SERVICE INFORMATION NO. SI D4-040

New 2005 IGRF Magnetic Field Model for G1000 Equipped Aircraft
ATA-Code: 34-00

**** MANDATORY ****
SOFTWARE SERVICE BULLETIN
NO.: 0533

SUBJECT: New 2005 IGRF Magnetic Field Model for G1000 Equipped Aircraft

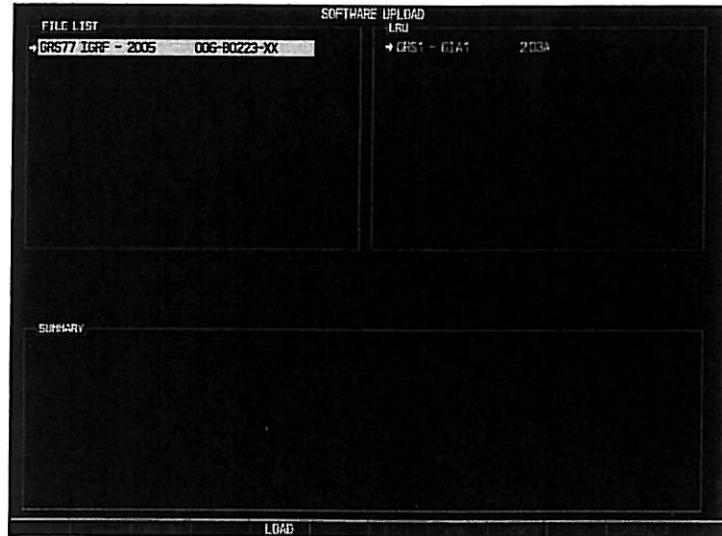
1. With the G1000 turned off, insert the 2005 IGRF Model Update Card into the top slot of the PFD.
2. Hold the ENT key down while powering on the MFD and PFD.
3. Press the FMS knob to activate the cursor.
4. Using the FMS knob highlight **GRS1 MV DB** in the LRU field.
5. If IGRF Part Number is 006-D0159-00 and Version is 2000.00 continue to step #6. If IGRF Part Number is 006-D0159-01 and Version is 2005.00, do not continue this procedure.

6. Press the FMS knob to deactivate the cursor.
7. Turn the small FMS knob to the Software Upload page in the System group.
8. Press the FMS knob to highlight **GRS77 IGRF – 2005 006-B0223-XX** in the File List.
